BID FOR: New Drainage Pump Station and
Drainage Improvements for Elise Avenue
Public Work Project Number 2009-009-DR
Bid No. 50-112381

JEFFERSON PARISH DEPT. OF PUBLIC WORKS
 NEW DRAINAGE PUMP STATION AND
 DRAINAGE IMPROVEMENTS FOR EUSE AVENUE
 MECHANICAL SITE PLAN

JEFFERSON PARISH DEPT. OF PUBLIC WORKS
 DRAINAGE IMPROVEMENTS FOR EUSE AVENUE
 NEW DRAINAGE PUMP STATION AND
 PIPE DETAILS

MECHANICAL SITE PLAN
 SCALE: 1" = 2'-0"

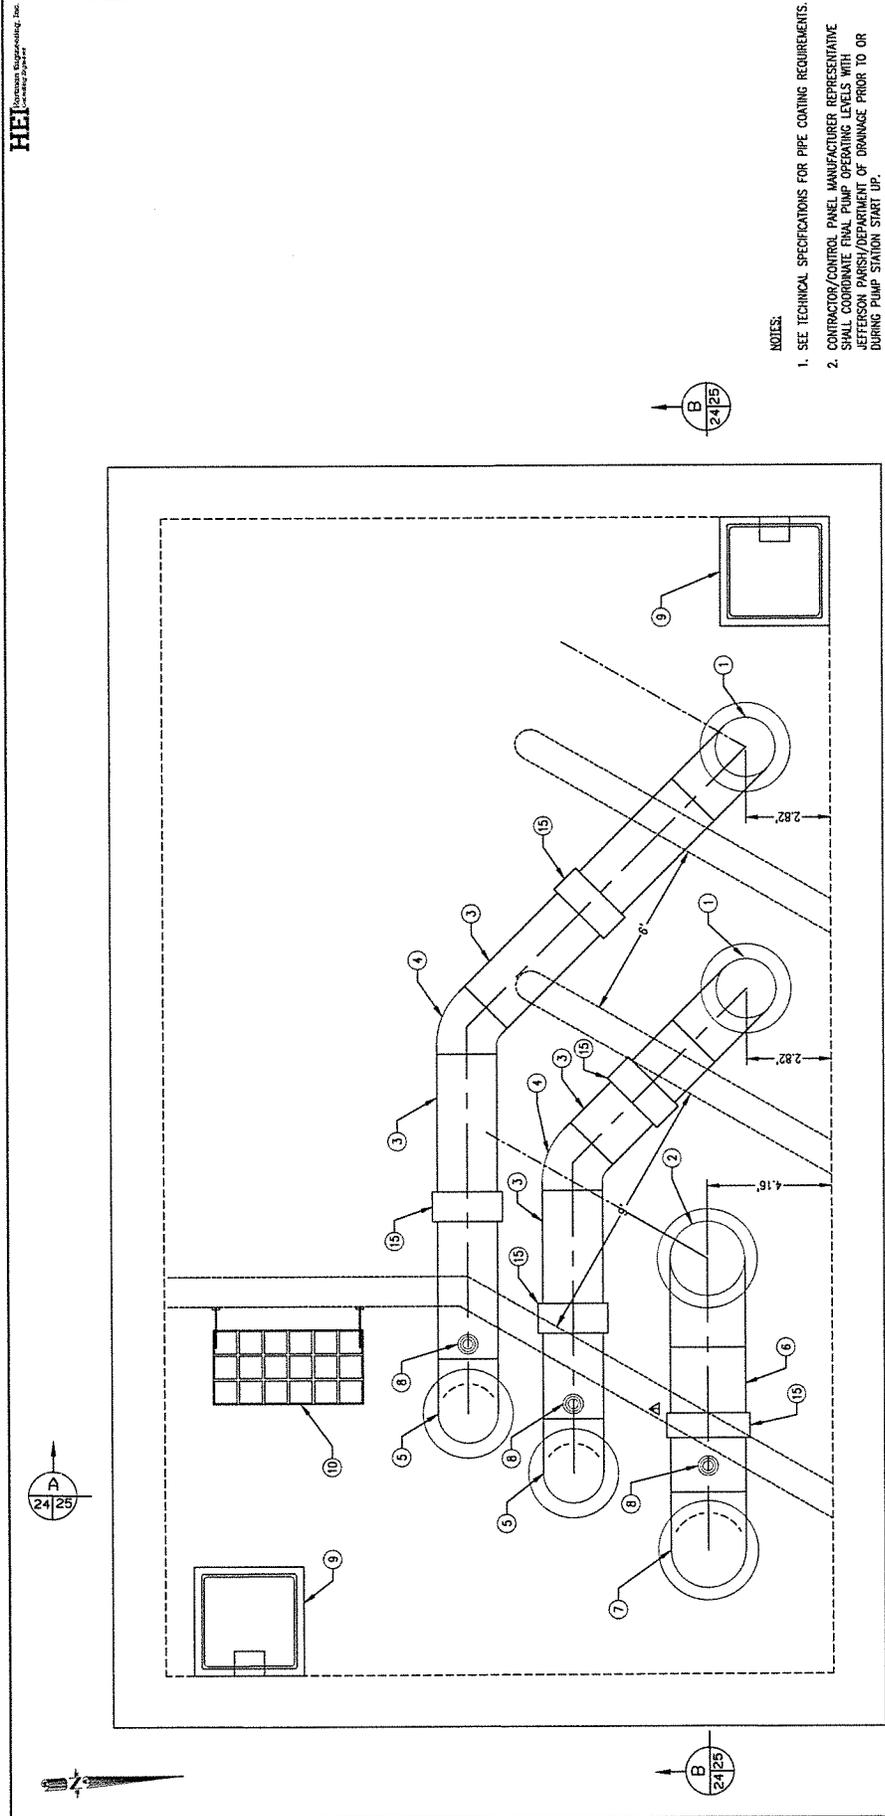
6: Plan sheets 24, 25, and 27 have been modified to reflect the change in pipe diameter from 36" to 30". The attached plan sheets shall govern and replace any previous editions.

63 TREATED TIMBER SCADA POLE (ELEVATION)
 SCALE: NOT TO SCALE

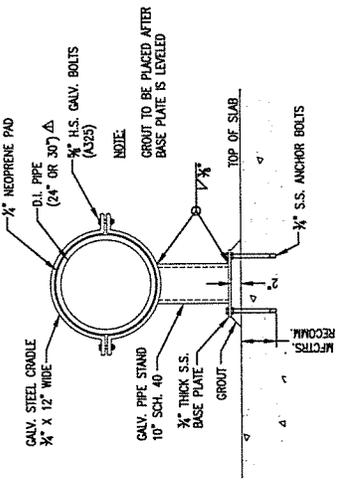
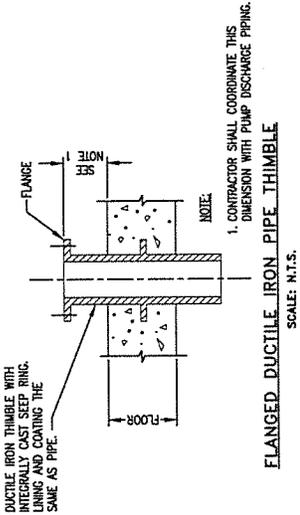
16: Is the Contractor required to provide the scada pole? If so, please provide a detail.

Yes, the Contractor shall fully furnish and install the scada pole and all its components. The Jefferson Parish SCADA Division Pump Specifications have been added to the specifications as "Appendix I" and Technical Specifications Section 53 – "SCADA POLE AND SCADA COMPONENTS" have been added to the Technical Specifications as page TS-123. Page TS-123 is attached to this addendum and shall be included with the specifications. A pole detail has been included in Plan sheet 27, which is attached to this addendum and shall govern and replace any previous editions.

A new pay item has been included for all SCADA related work as pay item NS-033 "SCADA POLE AND SCADA COMPONENTS" per LUMP SUM. An updated Louisiana Uniform Public Work Bid Form is attached to this addendum and shall govern and replace any previous editions.

SEWER STANDARD DETAIL

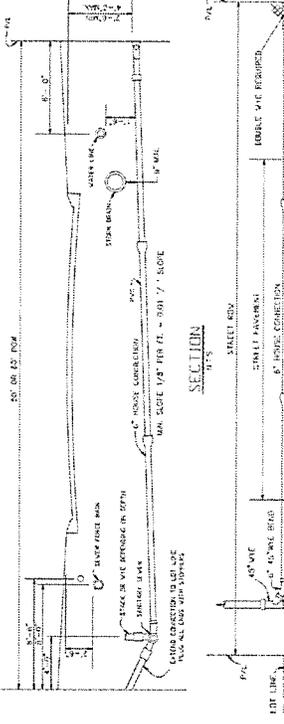
8: Plan Sheet 205: The Jefferson Parish Sewer Standard Detail has been updated. Plan sheet 205 has been revised and attached to this addendum. The attached plan sheet 205 shall govern and replace any previous editions.
